**38TH AND TOWER SITE PLAN**  
**LOTS 1, 2, 3, 4 & 5 AND TRACTS A, B, C & D OF BLOCK 1**  
**TOWER BUSINESS CENTER SUBDIVISION FILING NO. 1**

SUBMITTAL - 07/16/2018  
 SUBMITTAL - 08/19/2019  
 SUBMITTAL - 09/27/2019  
 SUBMITTAL - 11/08/2019  
 SUBMITTAL - 11/26/2019  
 SUBMITTAL - 09/11/2020  
 SUBMITTAL - 12/11/2020

COVER SHEET  
 SHEET 1 OF 27

**SITE PLAN**  
SCALE: 1" = 50'-0"

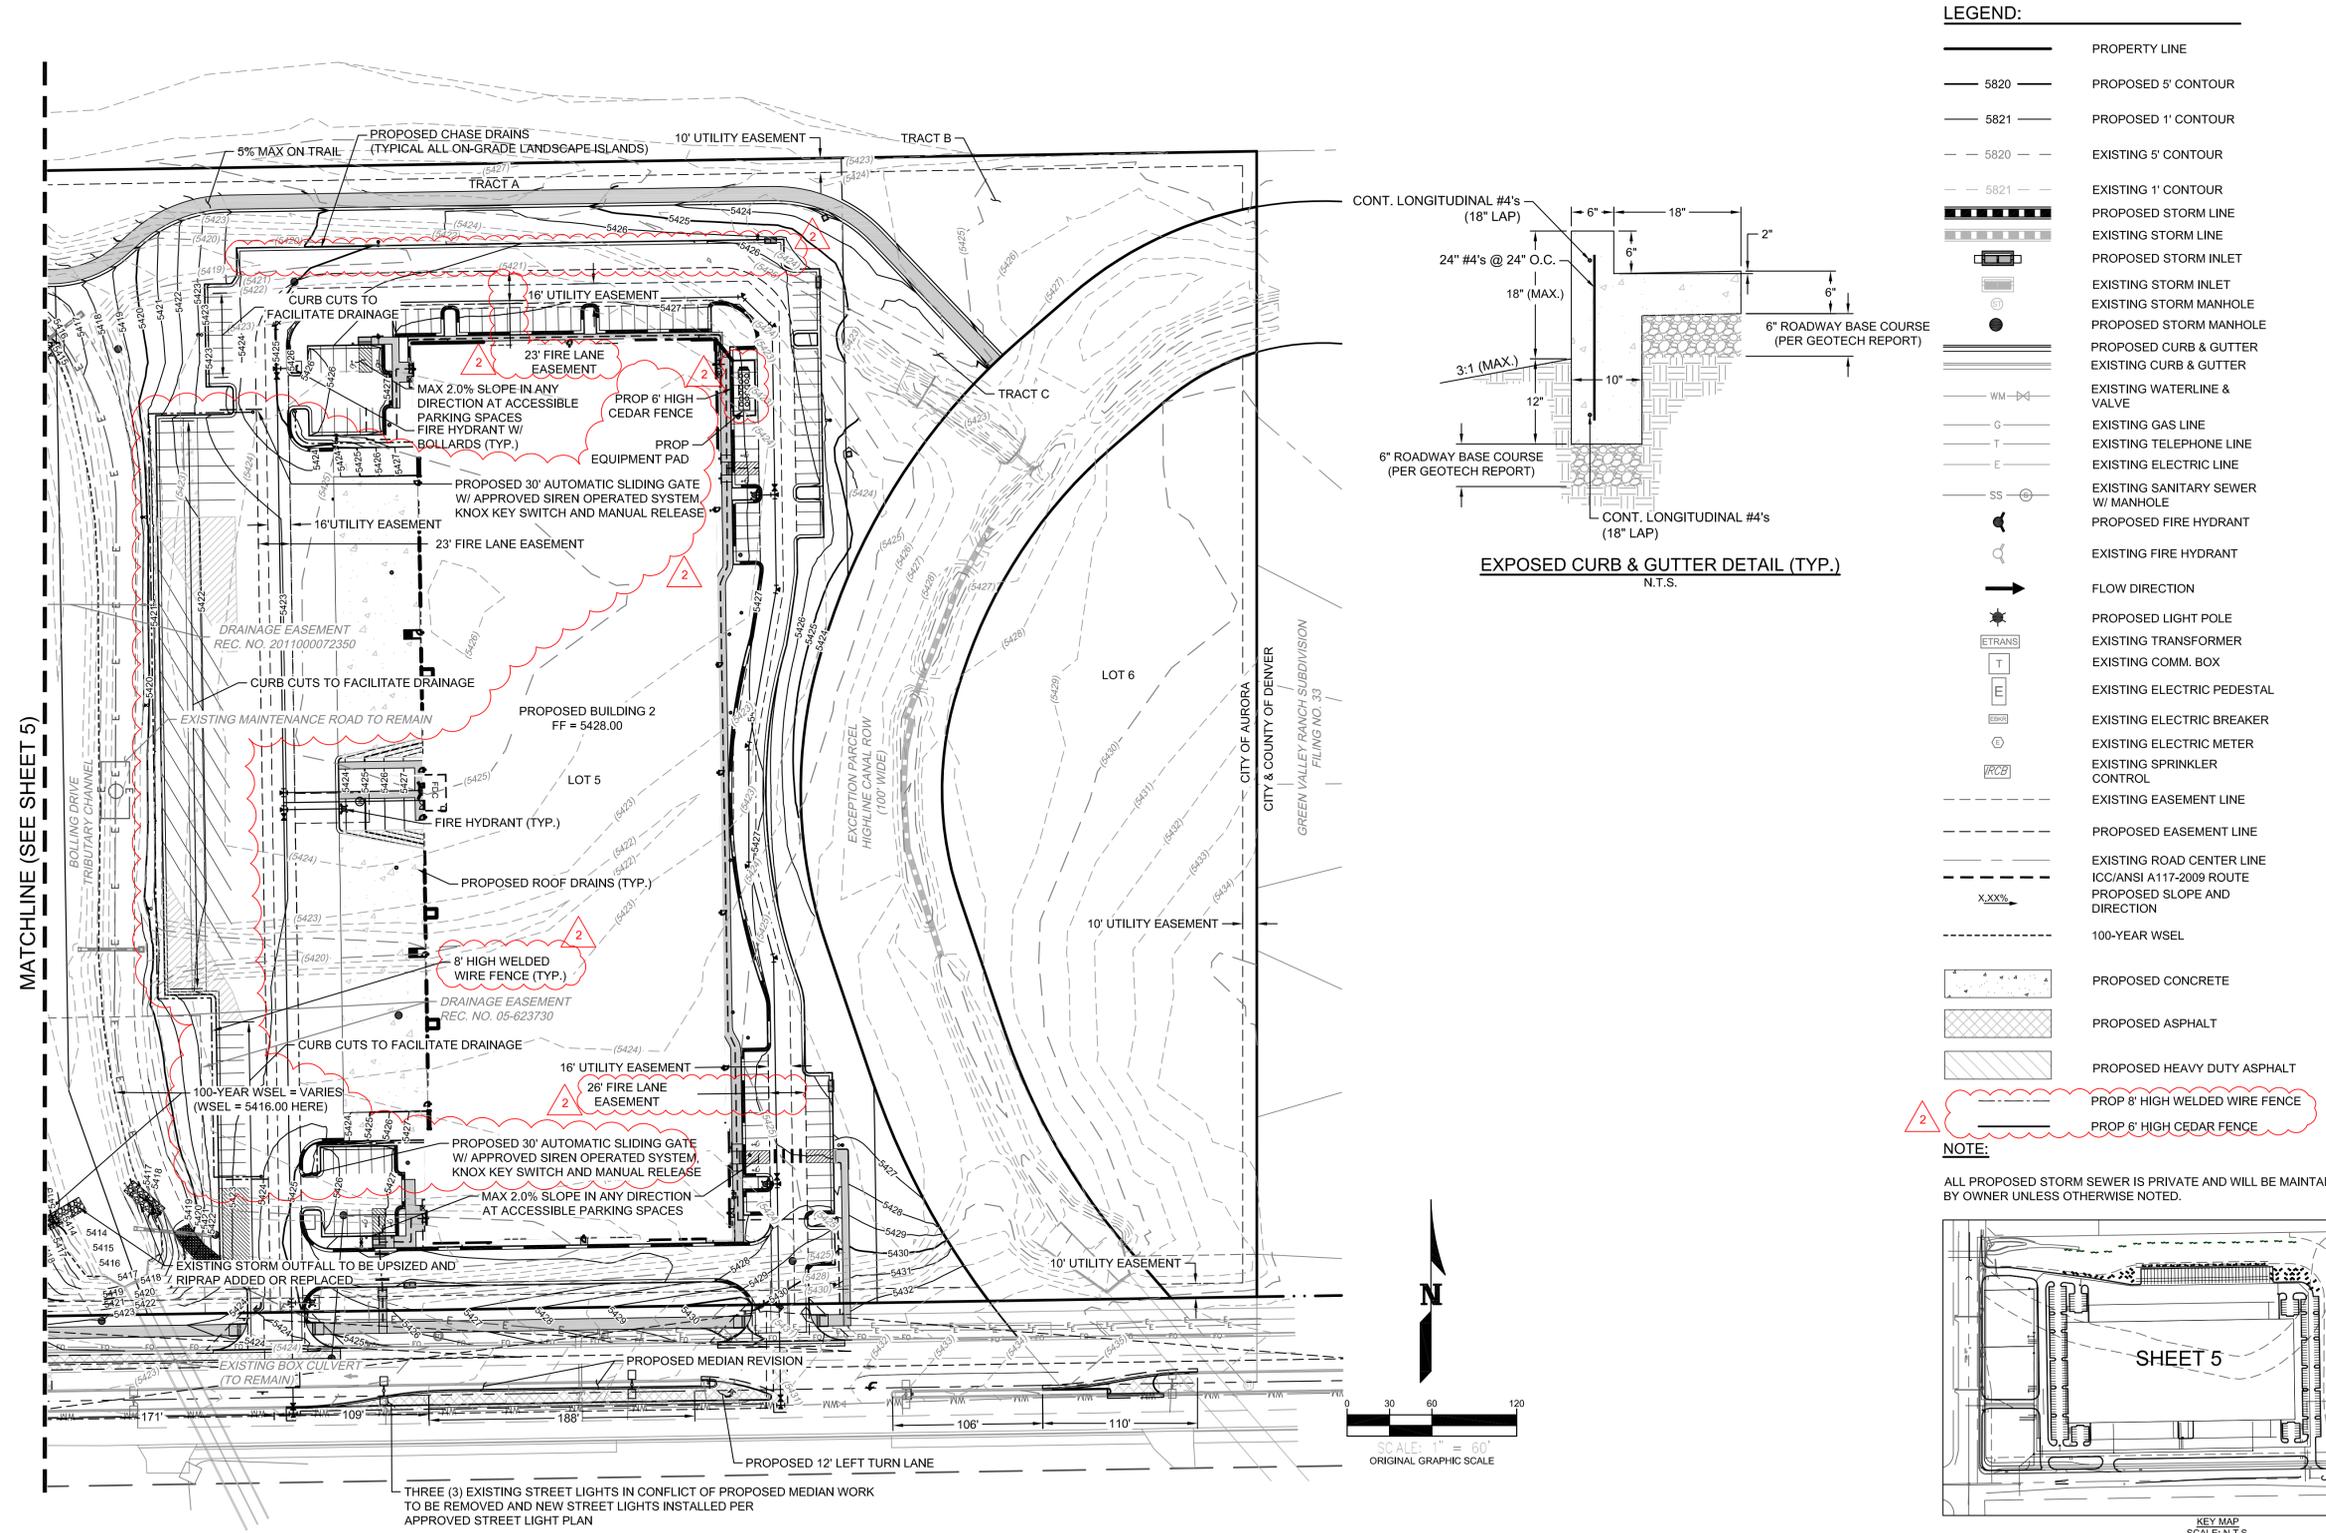
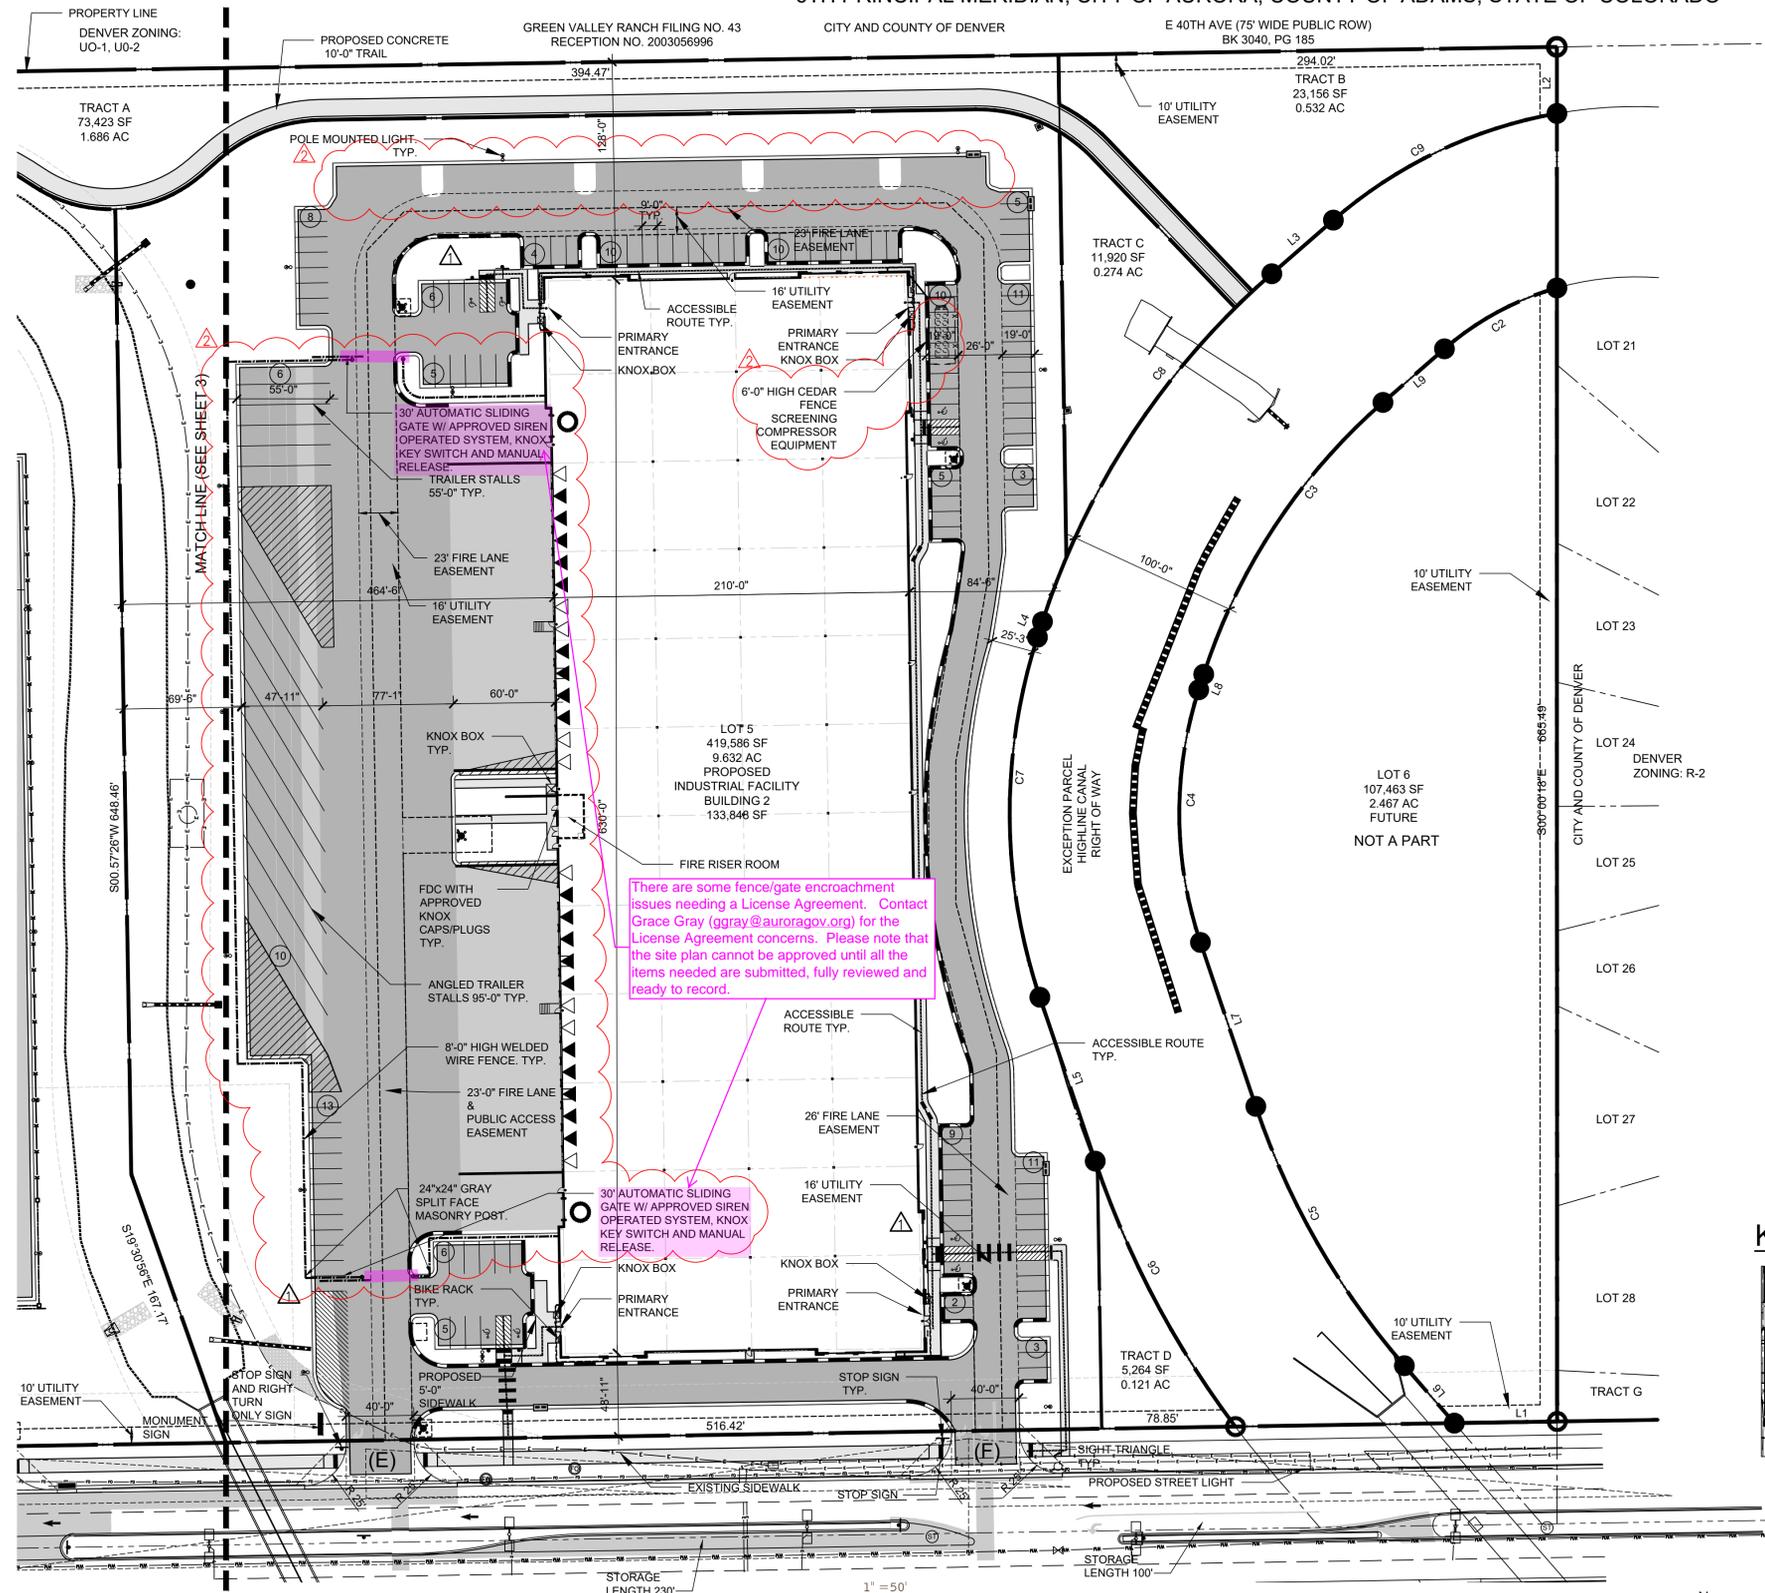
There are some fence/gate encroachment issues needing a License Agreement. Contact Grace Gray (ggray@auroragov.org) for the License Agreement concerns. Please note that the site plan cannot be approved until all the items needed are submitted, fully reviewed and ready to record.

NOT FOR CONSTRUCTION LANDSCAPE PLAN SHEET 14 OF 27

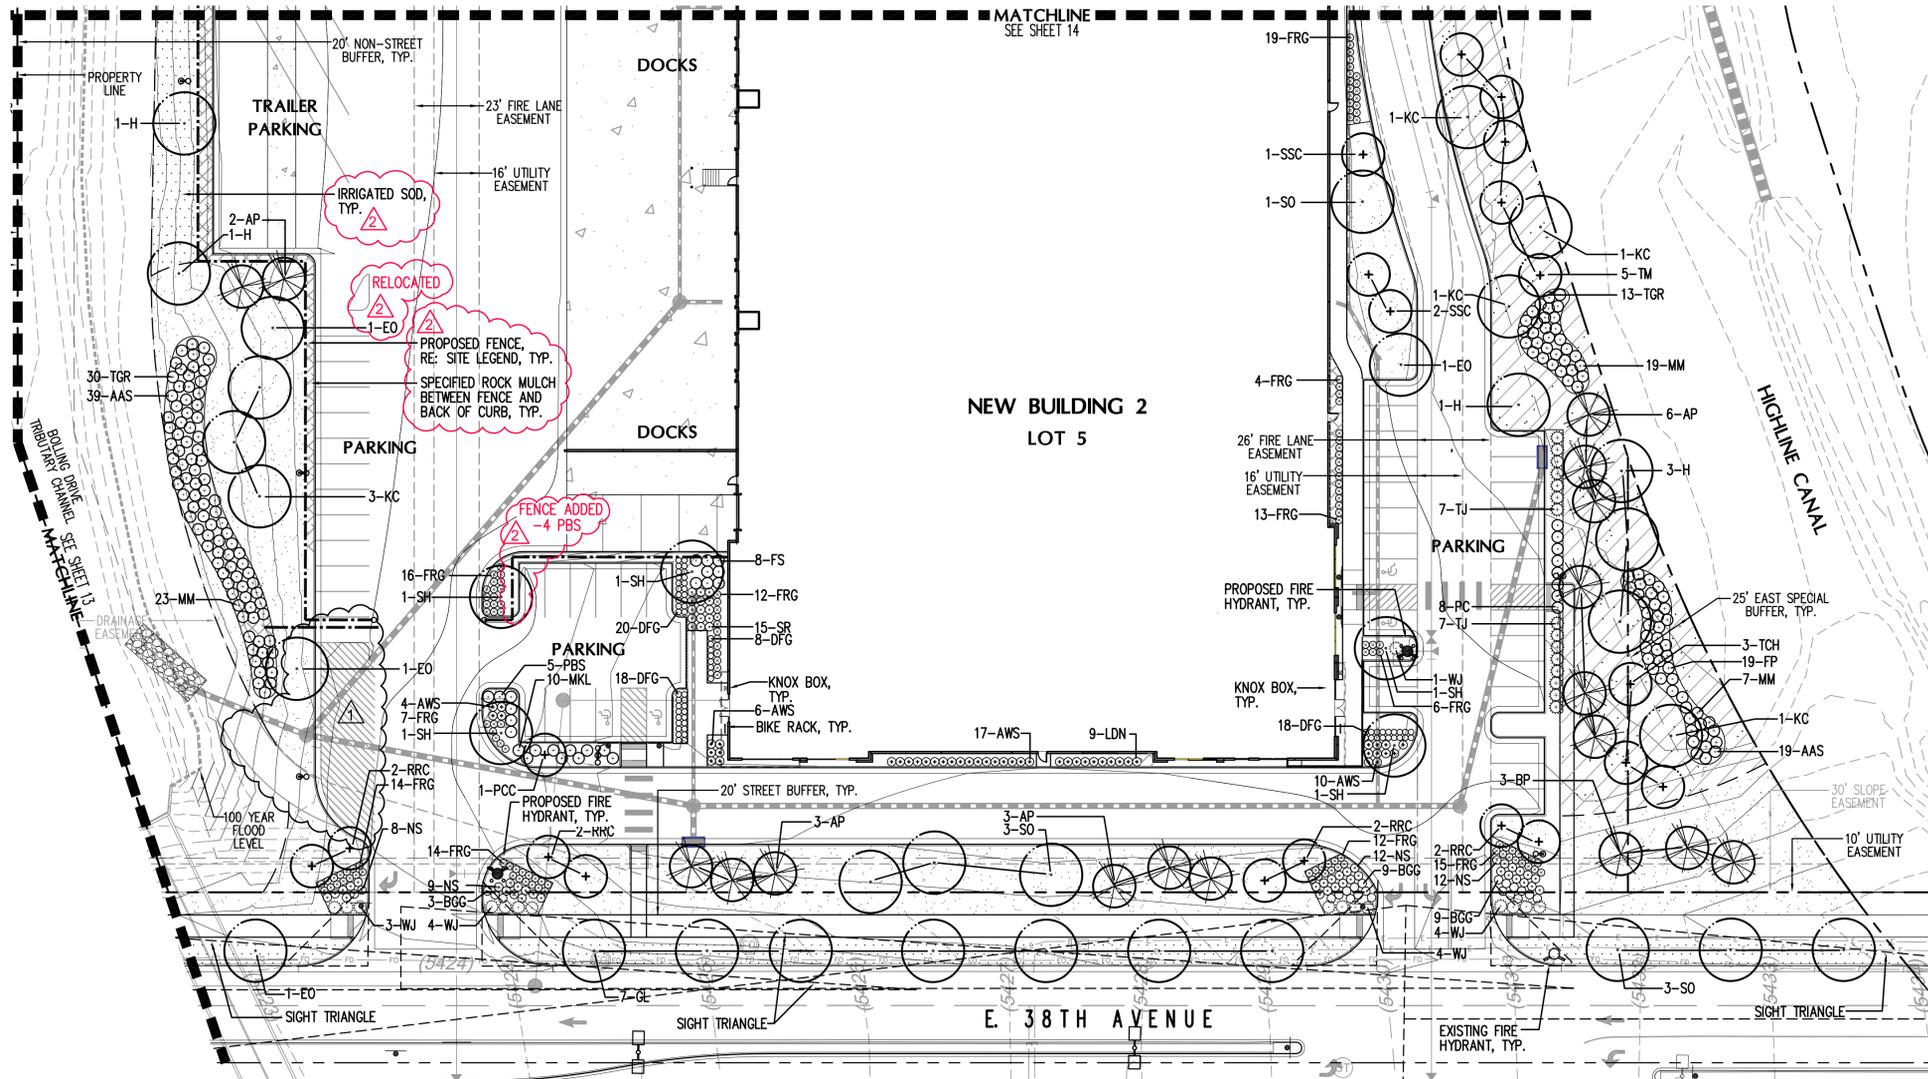
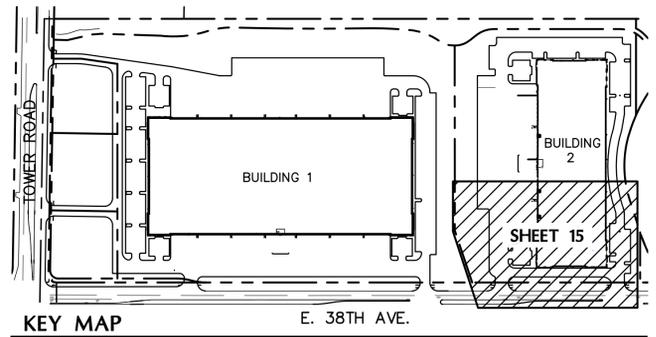
per the cover letter, these islands are being removed for truck circulation but the trucks and/or trailers will not be parked along this curb. Please note the area is "no parking" and add signs accordingly.

1. Why are landscape islands being removed?  
The maximum number of parking spaces allowed in a row is 15. Revise the plans to show clearly each parking island with 15 or less parking spaces between islands. All of the plants in those islands need to be shown clearly on the plans. If plants are being removed they need to be replaced in other locations and noted on the plant legend. The plants are not clear on what you are doing. Revise the plans to make it clear how many landscape islands there will be and the plants that are required in each island. The end of a parking row requires a landscape island with a tree and six shrubs. Wood or rock mulch may be used. Adjust the tables as needed.
